TB0058 Change of Twistlock Detent Spring

Date: 6 Sept 2007	Author: Neil Savage	Version 1	Cross Ref:
-------------------	---------------------	-----------	------------

Spring Identification Table

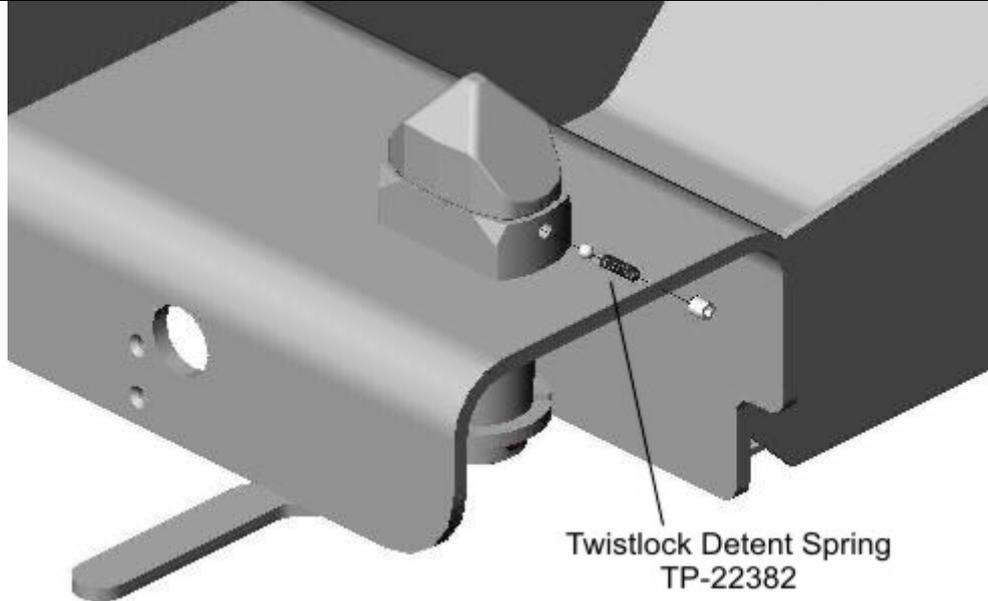
The springs used in the twistlock bodies to provide the detent locking have been changed to make it more robust in the field. The uncompressed length has been increased and the wire diameter reduced.

Old type	New type
Uncompressed Length	11mm	20mm
Wire Diameter	1.6mm	1.2mm
